# UNITED STATES PATENT AND TRADEMARK OFFICE

APPLICATION NO.	FILING DATE	FIRST NAMED INVENTOR	ATTORNEY DOCKET NO.	CONFIRMATION NO.
10/702,345	11/06/2003	Larry R. Cox	58970US002	8105
32692	7590	08/24/2004	EXAMINER	
3M INNOVATIVE PROPERTIES COMPANY			LE, THANH TAM T	
PO BOX 33427			ART UNIT	PAPER NUMBER
ST. PAUL, MN 55133-3427			2839

## Office Action Summary

## DETAILED ACTION

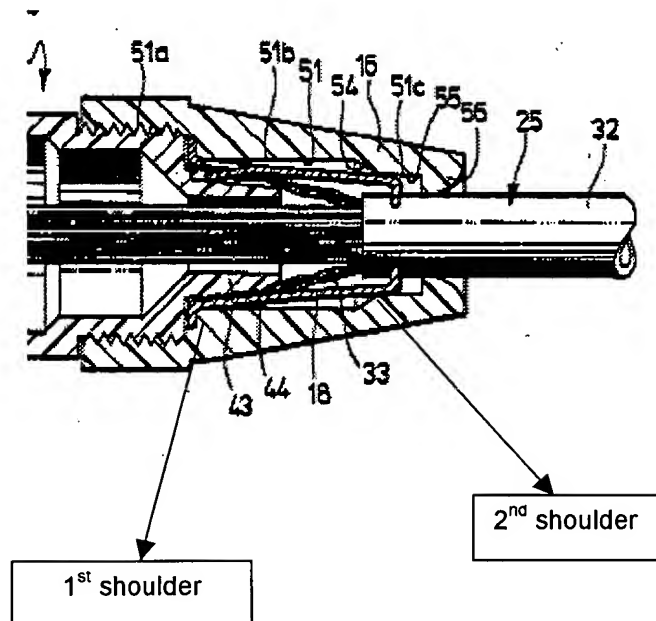
7. Claims 1-5, 7 and 28-33 are rejected under 35 U.S.C. 102(b) as being anticipated by Abendschein et al. (4,795,229).

Abendschein et al., figures 2 and 3, disclose an anchored fiber cable and housing assembly, comprising:

- a fiber optic cable (25) comprising a strength member (33) and jacket (32) around the strength member, wherein the cable including a first end and a second end;
- an anchor mounted on the cable at the first end, the anchor including an inner sleeve (17) and an outer sleeve (18), wherein the strength member including a first end at the first end of the cable structurally engaged with the anchor; and
- a housing (16) comprising an anchor cavity (51) and a cable inlet (53), the anchor cavity comprising a first shoulder (see a figure below) for engaging with the anchor, wherein the anchor is mounted in the housing cavity and the cable extending through the cable inlet, and wherein the first shoulder is engaged with the anchor to prevent the anchor from exiting the housing through the cable inlet.

Regarding claim 3, wherein the anchor cavity comprising a second shoulder (see the figure below), wherein the housing comprising an optical fiber outlet (56), and wherein the second shoulder is engaged with the anchor to prevent the anchor from exiting the housing through the optical outlet.
